**RE: PPSSEC-36 (DA-125/2012/C) – 20 ILLAWONG AVENUE, TAMARAMA – RESPONSE TO DEAP**

Reference is made to the modification application described above. Following the deferral of this application by the Sydney East Central Planning Panel (SECPP), the application was considered by the Waverley Council Design Excellence Advisory Panel (DEAP) at the meeting of 17 June 2020.

## Penthouse Awning Roof Profile

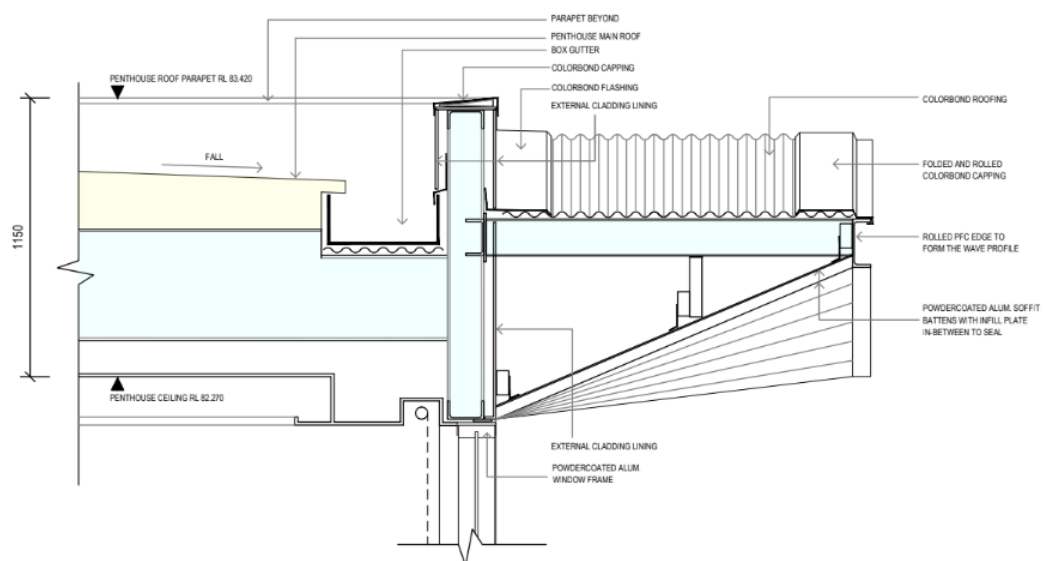
2. *There is a need for further design resolution in detailing of the proposed roof edge in order to achieve a lighter appearance (thin profile edge), and consideration of the soffit and options for the batten treatment.*

A 1:20 section drawing of the penthouse awning (excerpt below) provides a visual explanation of how the roof profile has changed in the current set of renders. These changes cannot be perceived in the 1:200 architectural plans, as such, the section drawing is provided to aid the DEAP in understanding how the renders have changed. There are no objections to this section plan being referenced within a modified development consent.

This suggestion has been adopted in the amended design – refer to 1:20 section drawing.
